ATTACHMENT 1

MSW Comments on Bowdens Response to
Submissions and the Proposed Amendment
(Michael White, March 2022)

MSW Comments on Bowden's Response To Submissions Report and the Proposed Amendment

Figure 18. The median performance rises from Worldwide Hydraulic Excavator Annual Unit Production (t/CuM of Capacity) 2003-2010 by Performance

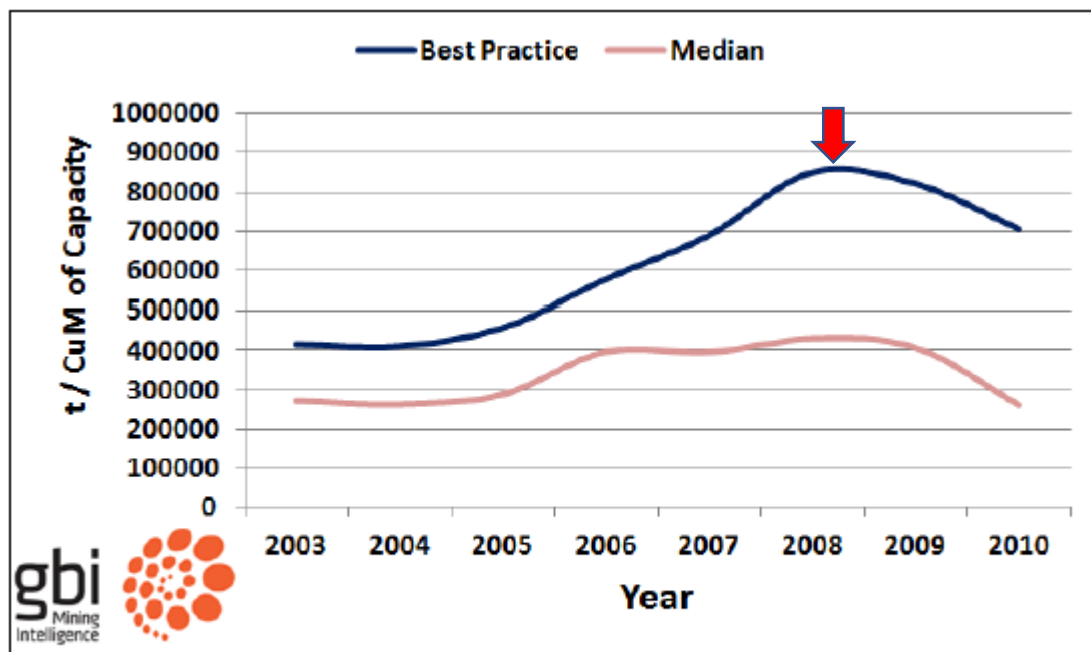
One Hitachi Ex1900 excavator fully trucked would struggle to move even half this amount. This 190-tonne class excavator typically operates with a 12 cubic metre bucket.

Shown below is an extract from a paper published in 2012 by Dr Graeme Lumley⁵ of GBI Mining Intelligence (now part of PwC) showing worldwide performance of excavators in tonnes per cubic metre of bucket capacity.

If one uses the 2008 world's best practice highest value of 850,000 tonnes per cubic metre and applies this to a 12 cubic metre bucket the annual capacity for the world's best 190 tonne excavator is **10.2 million tonnes per annum**.

Figure 1 Average monthly rainfall data presented in Bowdens surface water assessment

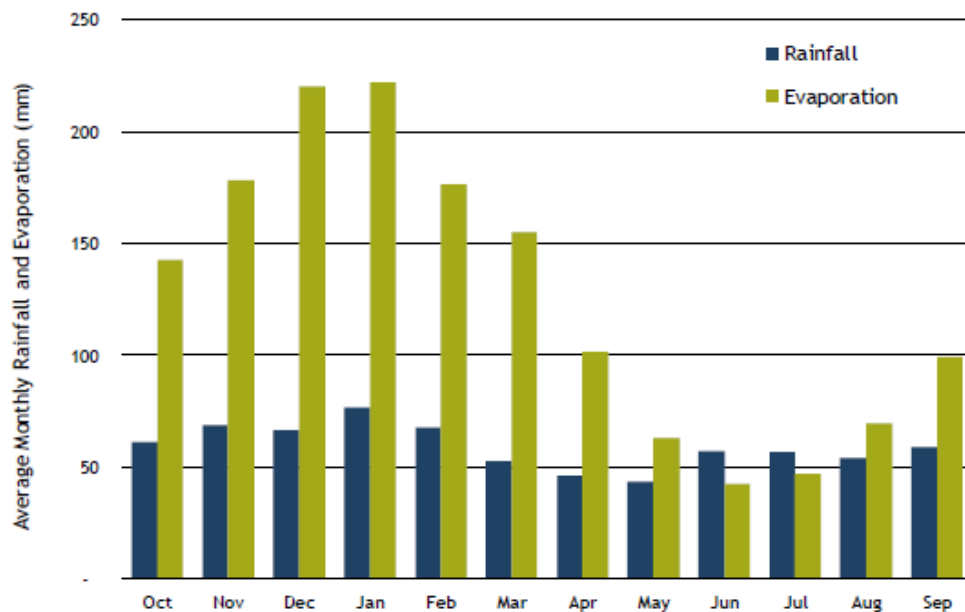
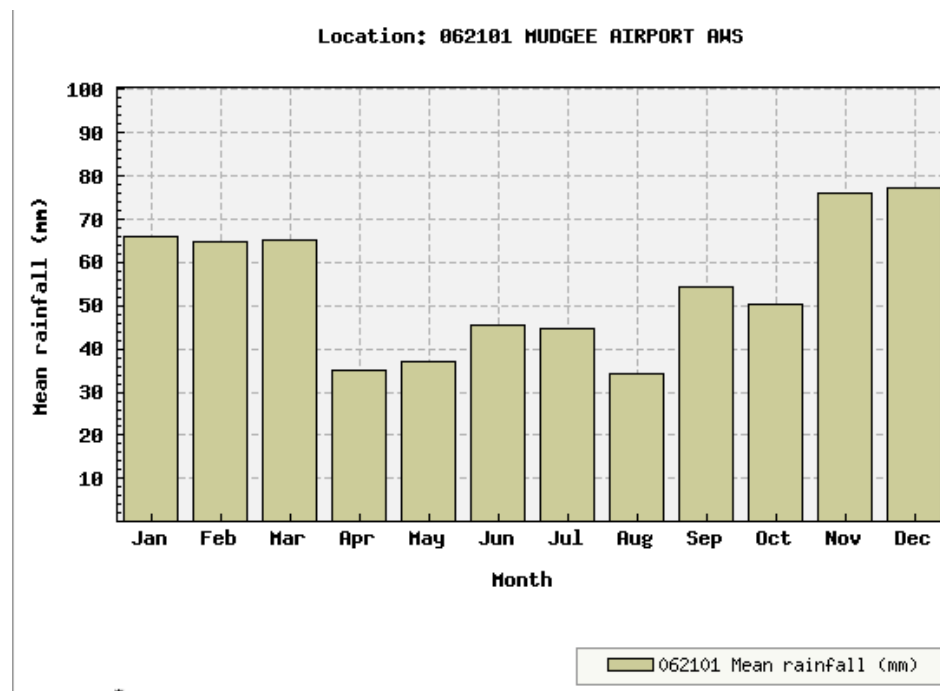
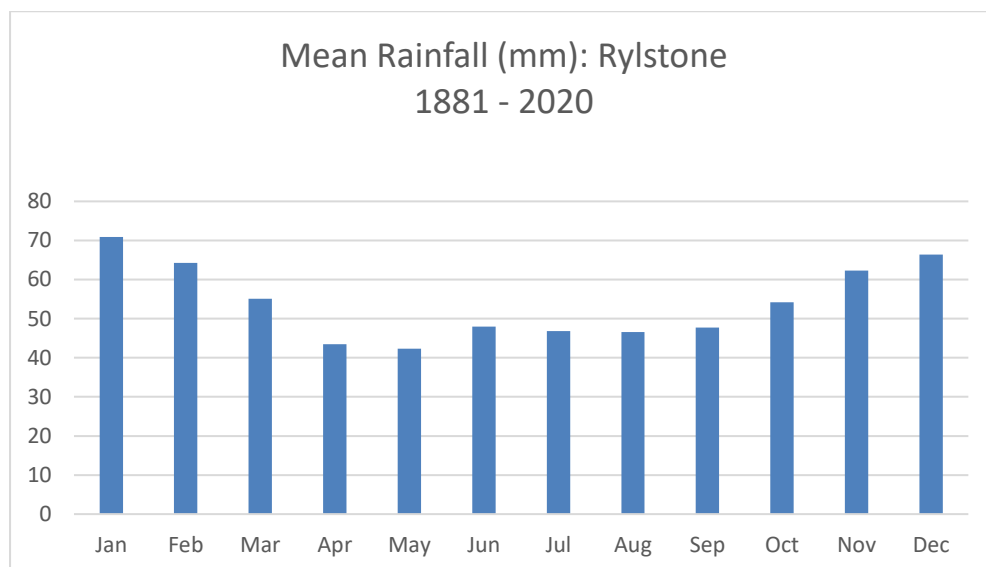
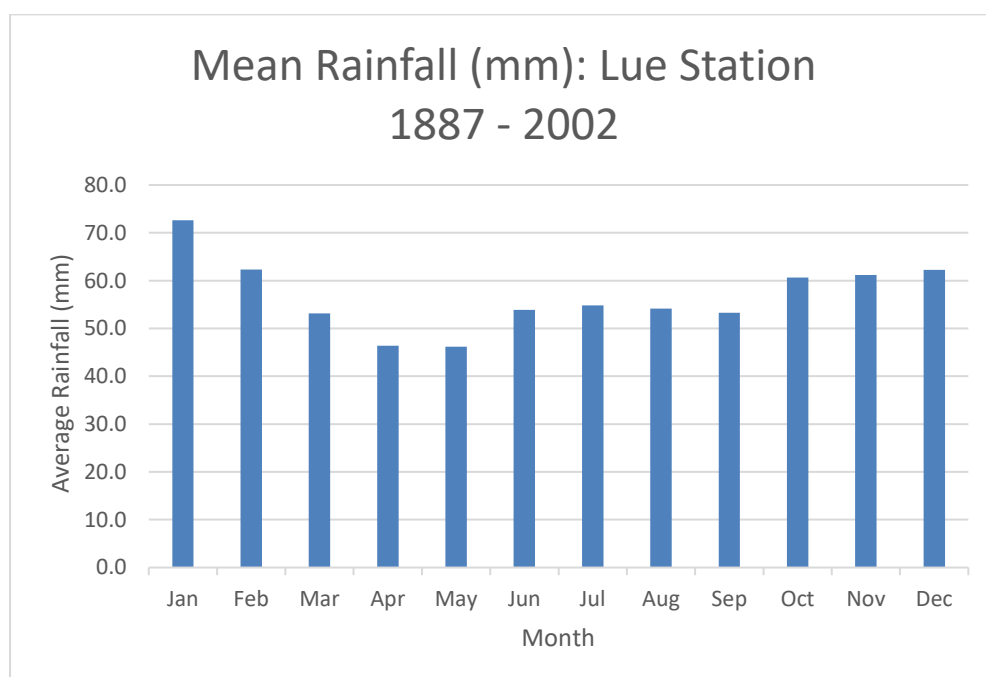
The Bowdens surface water assessment data appears to show a monthly average that exceeds 75mm over summer. This is incorrect, as evidenced by the rainfall data from Mudgee (26km west of the mine site), Rylstone (22km south of the mine site) and Lue Station.

Many of the other months are also too high when compared to Mudgee, Rylstone and Lue rainfall statistics. The data should be reviewed and revised down so as to not incorrectly inflate the amount

Figure 5 Annual monthly rainfall data presented in Bowdens surface water assessment

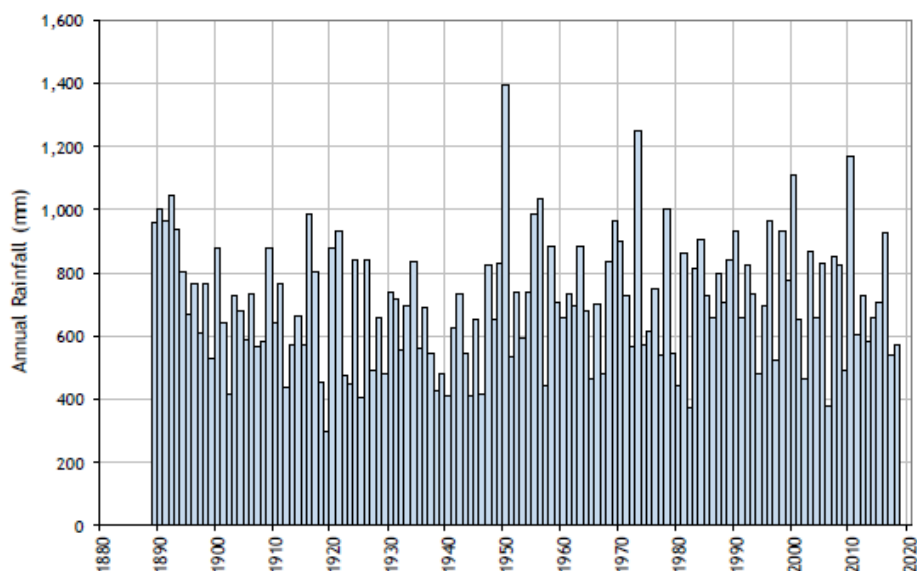
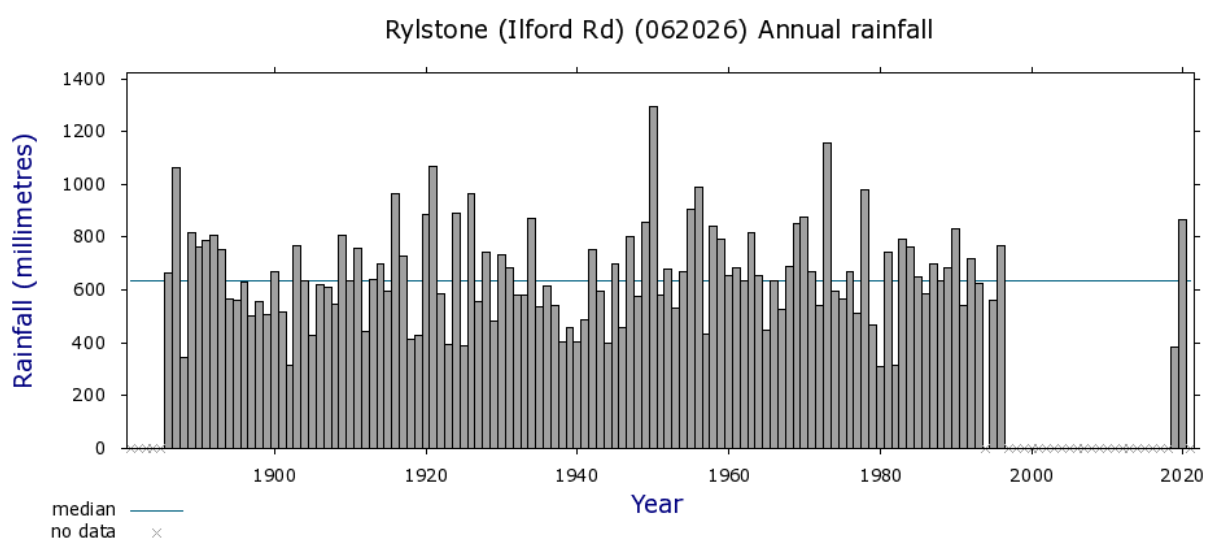
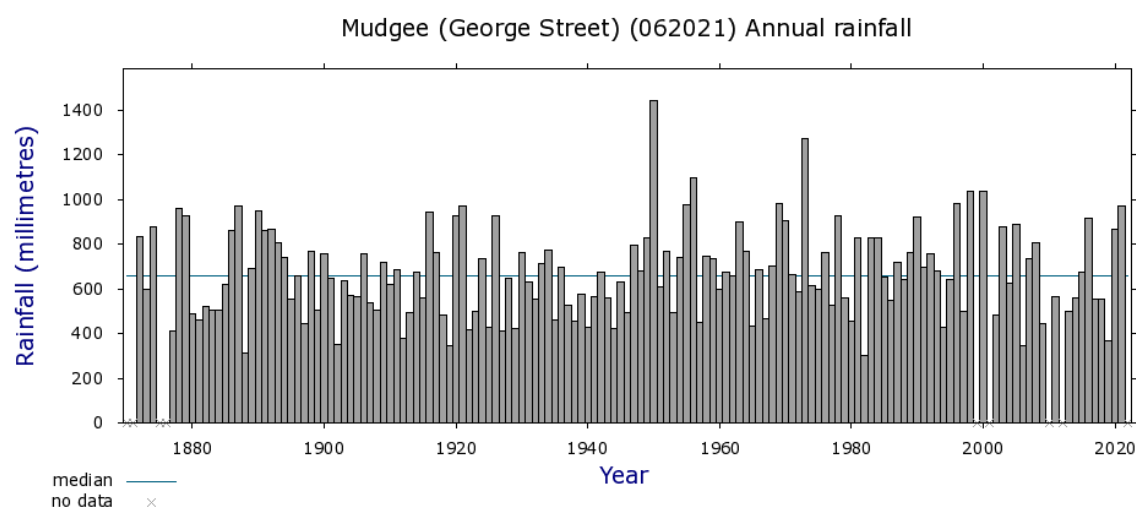
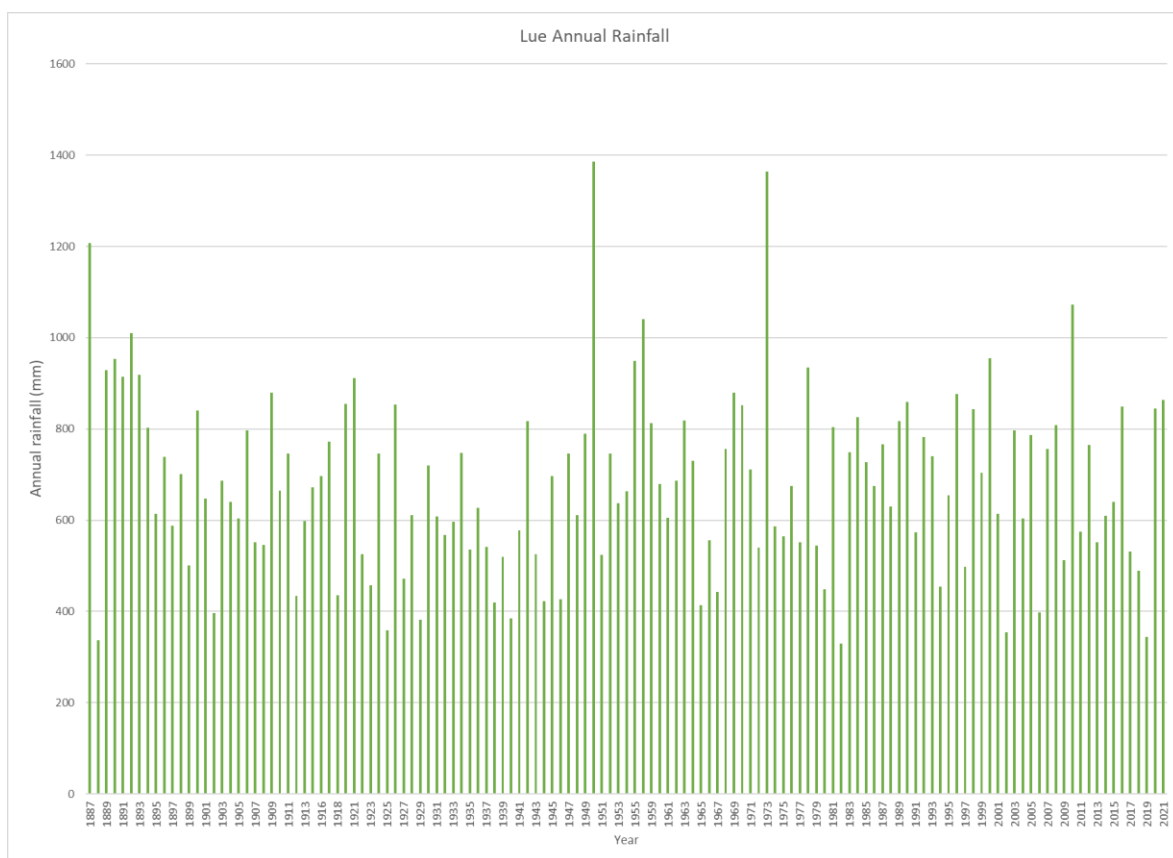
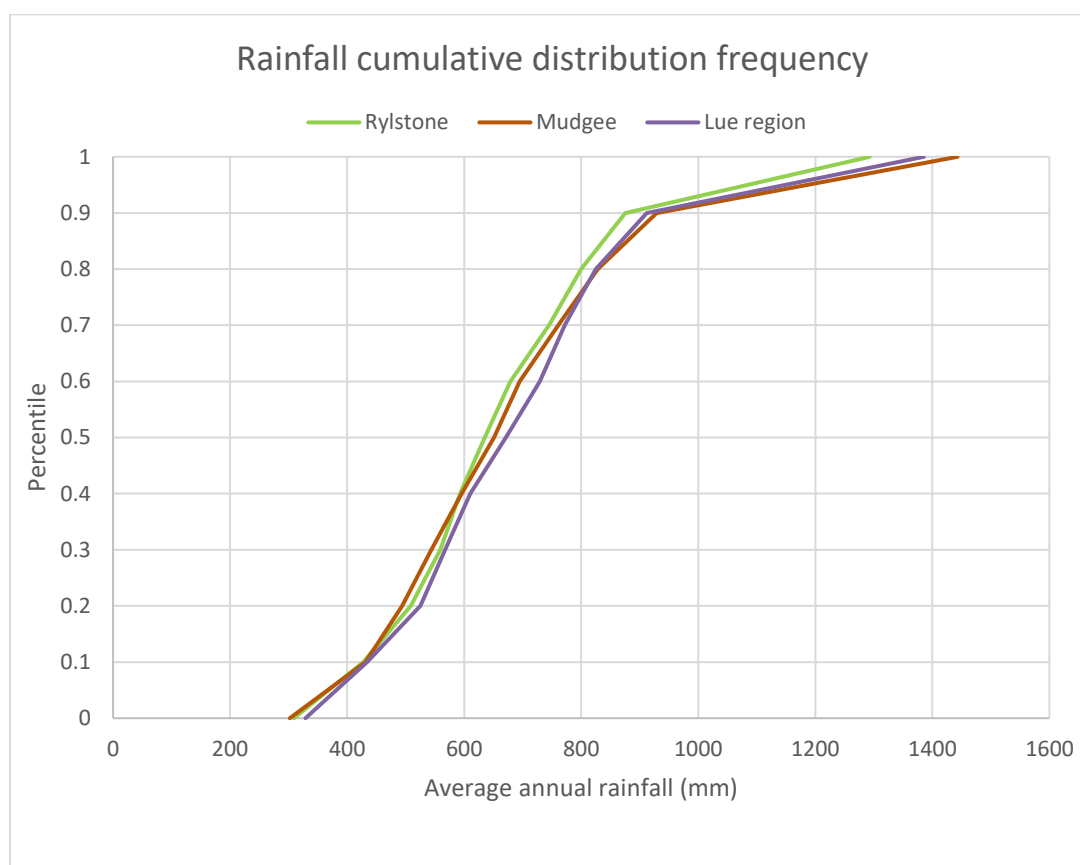
The percentiles for Mudgee, Rylstone and Lue region have been calculated and are shown in Table5 and Figure 10. Based on the data from these three areas, in one in every five years the climatic conditions are akin to a semi-arid environment, receiving little more than 500mm per annum.

The number of very low rainfall years is clearly not reflected in the Bowdens' surface water assessment annual rainfall data, which has only three years of less than 400mm. This in part seems to be a deliberate attempt to distort the data, as it has excluded 1888 and 2019, both of which are very dry years. Actual long term rainfall data recorded by landholders in the region show there has

Figure 2: West-east modelled cross section. Source: Adapted from Figure 51 from (Jacobs (Australia), 2020, pp. 5-143)

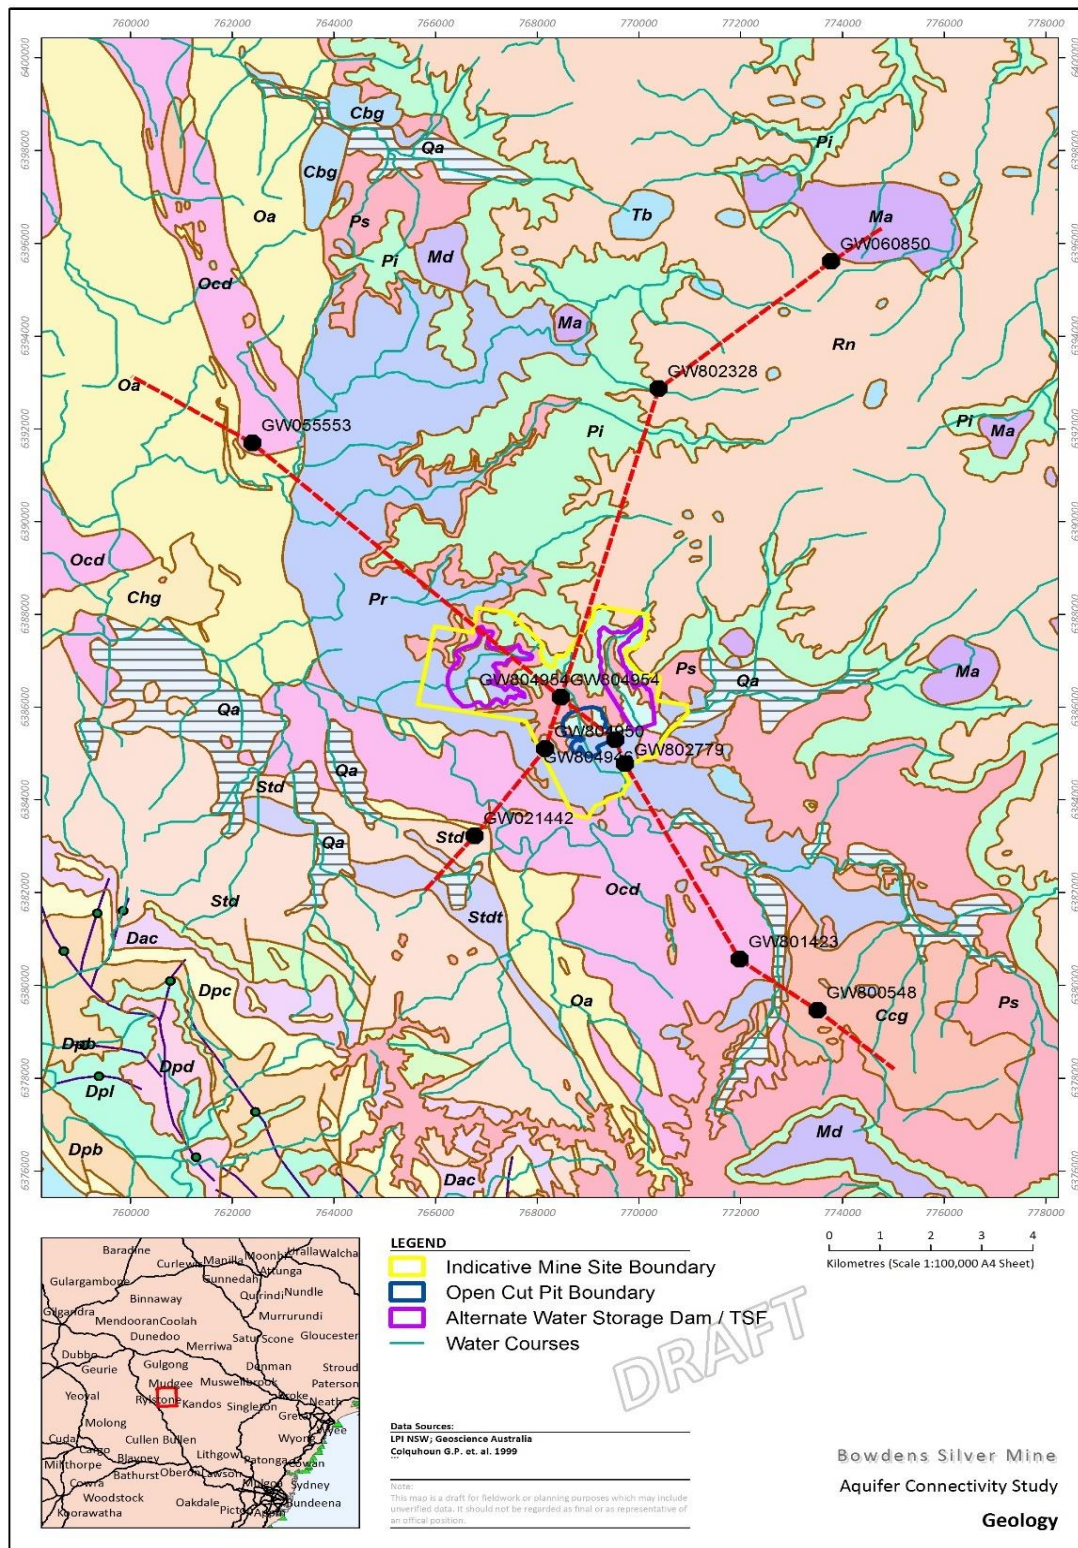
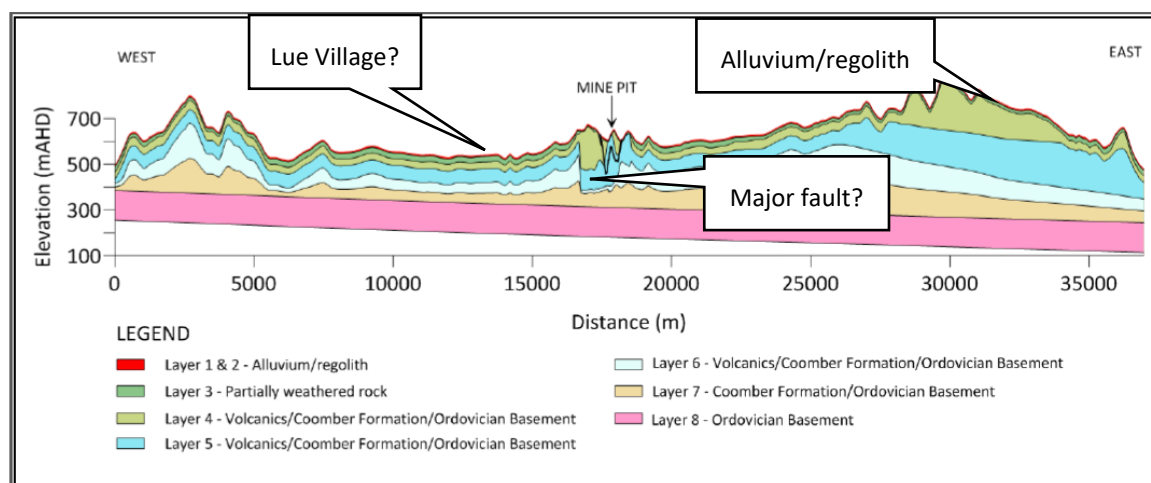
When this information is compared to the EIS interpretation (Figure 2) and while faulting can be inferred, the mapped outcrop of Late Ordovician-Early Silurian age Ocd (Coomber Formation) near Lue village north west of GW021442 is not presented in the EIS. Suggested cross section transects are shown in Figure 1.

This discrepancy (a lack of Ocd outcrop on Figure 2) highlights an area for future focus to adequately represent the hydrogeology in the alluvium near Lawsons Creek proximal to Lue Village bores and the associated significant species.

Figure 1: Water source inflows (R. W. Corkery & Co., March 2022b, p. 20)

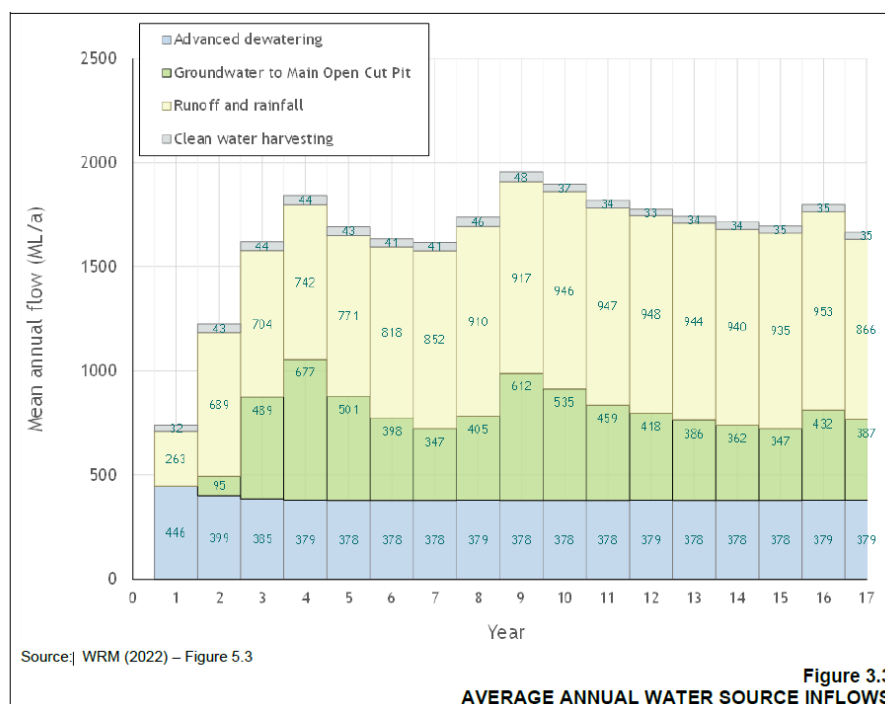
Over 1,000 ML/a of groundwater is expected to be harvested in Year 4. Figure 1 indicates that groundwater yields are not expected to change as open cut pit inflow rates change.

If no hydraulic barrier is modelled between the production bores and the pit, this implies capture and drainage of groundwater recharge over a large area such as the Cudgegong catchment - Figure 3 – or upstream in the Lawsons Creek Catchment. This water would otherwise report to other groundwater users. An updated water model balance (Table 2) provides useful data on where water enters and leaves the groundwater model (bounded by the red polygon in Figure 3). Production from “well” cells in the model is 1,816 ML/a and more work is required to determine how much is from bores within the site water balance.
